50-245

PROPOSED TECHNICAL SPECIFICATION CHANGES FOR MILLSTONE UNIT  
NO. 1, RELOAD 8

## 1. Reload 8/Cycle 9 Work and Extended Load Line Limit Evaluation

Figure 2.1.2 MILLSTONE APRM SCRAM AND ROD BLOCK TRIP LIMITING SAFETY SYSTEM SETTINGS

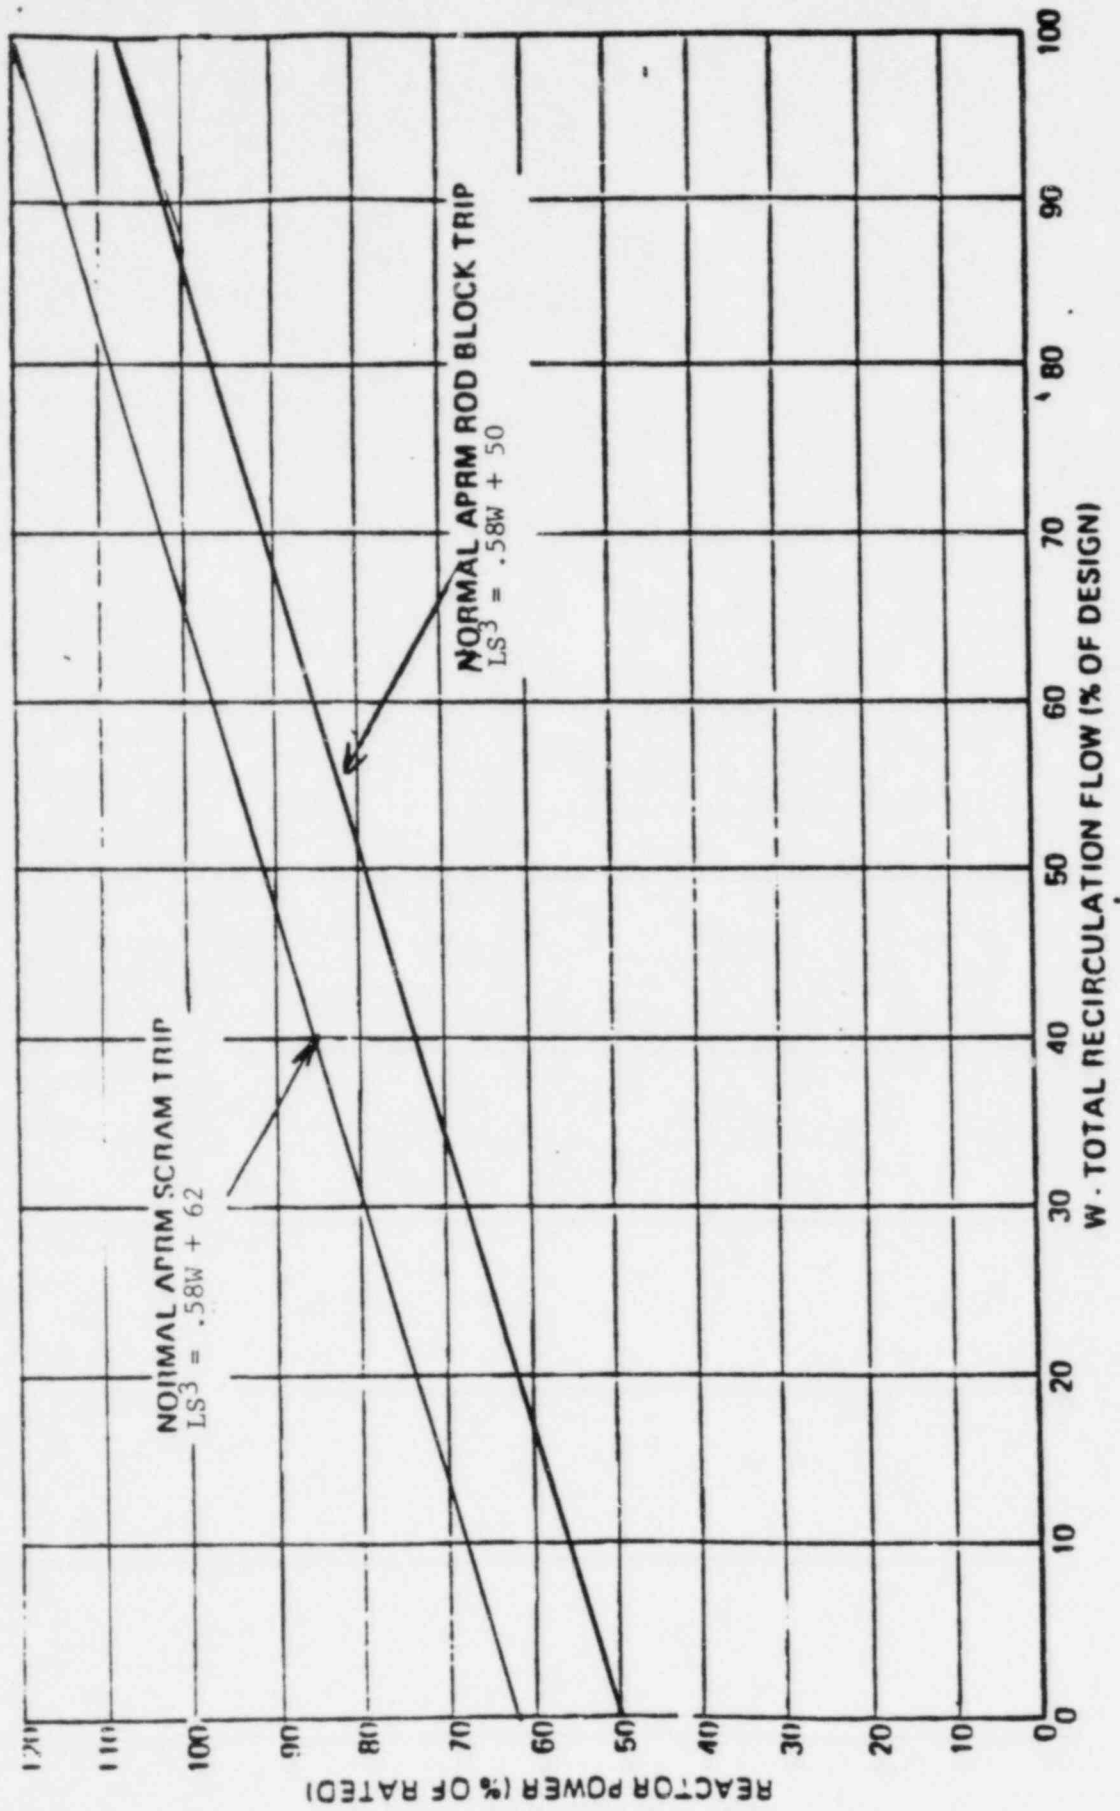
b. Figure 2.1.2 - New APRM and Rod Block Curves

These new curves are within the analyzed region and are not limited with respect to the safety analyses. The same reasoning applies for (b) and for (a).

- a. When the Mode Switch is in the RUN position, the APRM flux scram trip setting shall be as shown on Figure 2.1.2 and shall be:

$$S < 0.58 W + 62$$

- a. The APRM rod block trip setting shall be as shown in Figure 2.1.2 and shall be: (Run Mode)
- $$S_{RB} \leq 0.58W + 50$$

**FIGURE 3.3.1**

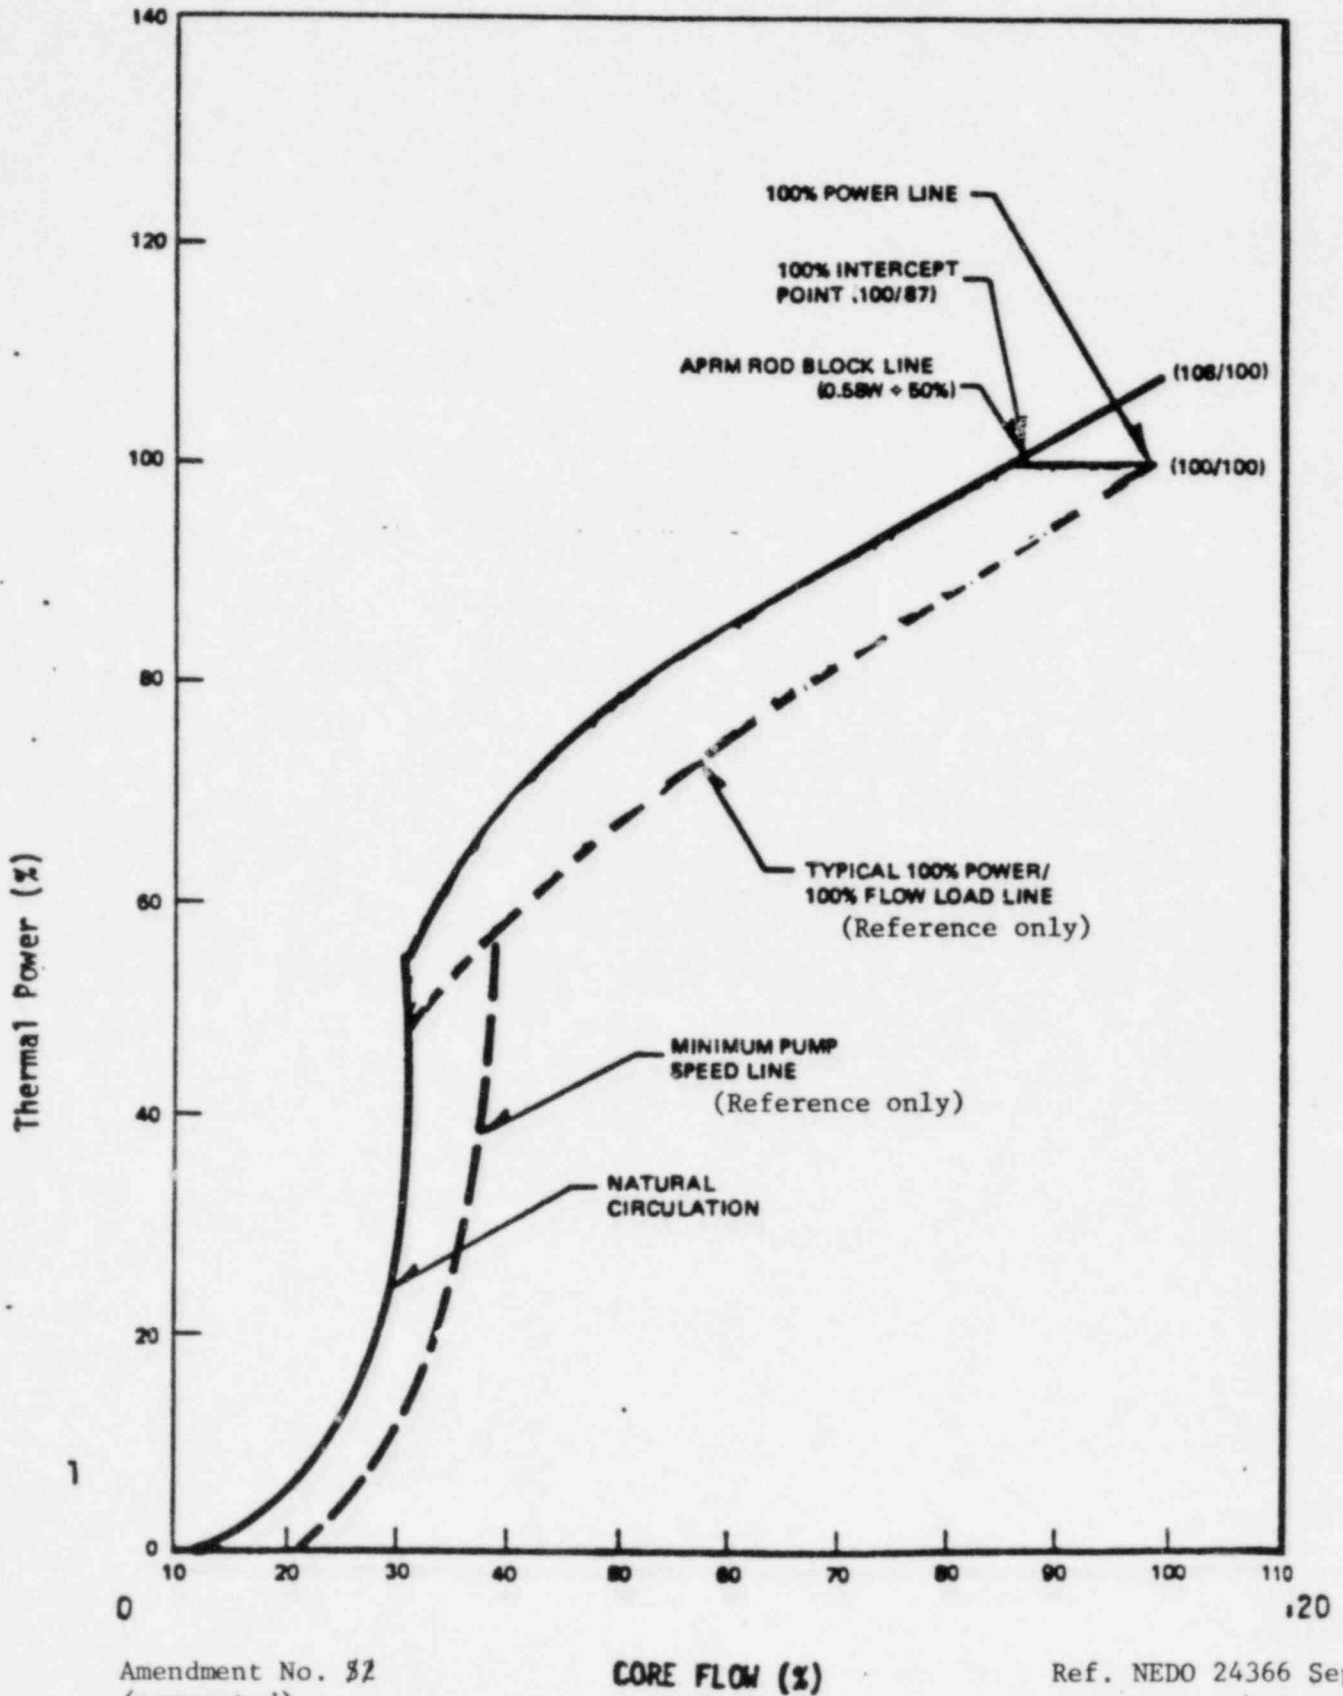
The present operating region for Millstone Unit No. 1 is refined by Figure 3.3.1 of the Technical Specifications and is valid for an area bounded by the recirculation pump minimum flow line, the present rod block LCO line up to 80 percent flow and 92.4 percent power and a Rod Intercept Line to the 100 percent flow/100 percent power.

New Figure 3.3.1 extends the normal operating region to 100 percent power and 87 percent flow with the boundaries being the Rod Block LCO Line and an intersecting line at 100 percent power. In defining a new region, we have also redefined the slope of the Rod Block and Scram Lines from 0.65W to 0.58W. This line is somewhat less conservative than the existing line but is shown to be bounded by the 100 percent flow/100 percent power intersect.

f. Figure 3.3.1 - Millstone Unit No. 1 Power Flow Map

This change explicitly defines the new operating region as discussed in the ELLA submittal and in this evaluation.
